Title	Deadline 3 Noise Responses		
Project	Gatwick Airport DCO		
Reference	28AD.NT.4.0	Author(s)	BHo
Date	13 May 2024	Reviewer	VC

1. This note provides Suono's response on behalf of CAGNE following submission by the Applicant of the Deadline 3 documents dealing with noise.
2. This note sets out a list of the high-level issues identified in the Deadline 3 documents provided by the Applicant. Our review has identified a number of highly important matters arising, rather than being able to confirm that our issues are resolved. More details can be provided on any of the matters we raise on request from the ExA.
3. Even basic information remains outstanding, as highlighted throughout this note. We request the ExA ask the Applicant to provide this outstanding information at the next deadline, in order to enable as much scrutiny as possible at this relatively late stage of the examination.

Graph 1: Central Case and Slower Fleet Transition

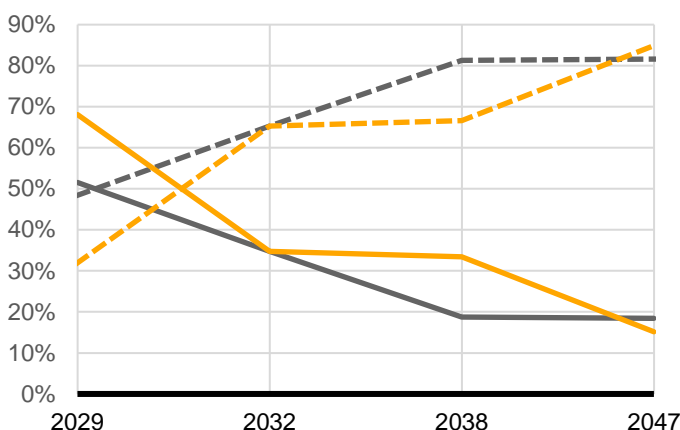
13. Generally, the Slower Fleet Transition forecast has a lower number of next generation aircraft within it, with the exception of 2032 where both forecasts have the same percentage of next generation aircraft and 2047 where the Slower Fleet Transition has a slightly higher percentage. This can be seen on the graph below, whereby the Slower Fleet Transition (SFT) generally lags behind the Central Case (CC):

14. If the Slower Fleet Transition forecast is exactly that, merely reflecting a slower uptake of new generation aircraft, one would expect that the noise contour areas between the two cases would

have some difference in area at the beginning, but that over time this area difference would reduce. When the fleets are both heavily modernised (in relative terms) in 2047, there should be little difference between the noise contour areas of both the Slower Fleet Transition and the Central Case. In fact, in 2047, the SFT is forecast to have a greater percentage of new generation aircraft than the CC, meaning noise contour areas for the former should be slightly smaller than the for the latter. This is not the case, as can be seen in the Diagram below, taken from APP-039.

16. The fact that larger (and assumedly noisier) MAX10s are replacing slightly smaller MAX8s appears to be the main reason that the noise contours are larger in future years, rather than a slower rate of transition. As noted above, inspection of the graph and diagrams above show that in 2047 there are more next generation aircraft in the Slower Fleet Transition than the Central Case, yet the diagram shows larger noise contour areas for the Slower Fleet Transition. We have major concerns arising from this.
